Issue	**1**
Factory ID	**920037**
Date of Issue	**04-Jun-2026**

M/S Stylers International Ltd. - Unit 2 (Raiwind)

Fire Safety Inspection Report

Pakistan Accord Initial Safety Inspection Report

Figure 1.5. Egress layout for Mill Building

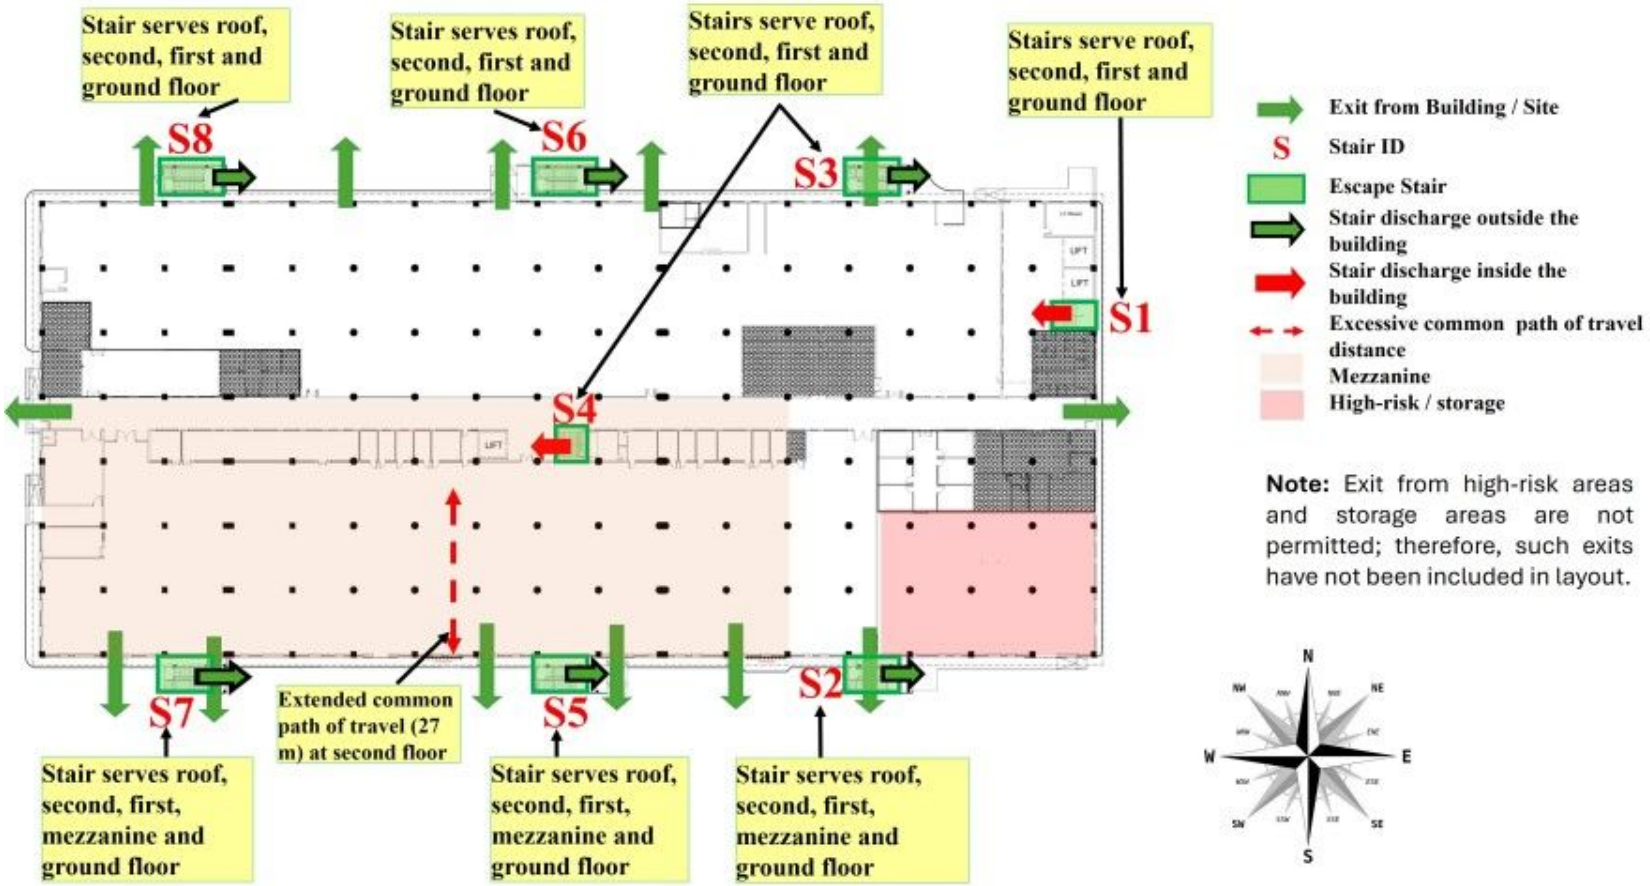
The travel distance issue was observed at second floor of the Mill Building. The number of exits is sufficient in all Buildings.

This is not always achieved, examples include (list not exhaustive):
- Common path of travel distances exceed permitted limits i.e. 27m common path of travel was observed at second floor of the Mill Building

Timeline	Remediation Plan
Medium Term CAP-0076289	Propose a plan for addressing the excessive travel distance through alternative escape routes and/or additional exits and submit to Pakistan Accord for review prior to commencing any rectification works on site. Review travel distances from all areas in the building(s) to ensure that they meet the limits in the Pakistan Accord Standard.
Longer Term CAP-0076290	Implement the plan previous reviewed by Pakistan Accord and ensure all travel distances to emergency exits meet the requirements of the Pakistan Accord Standard.
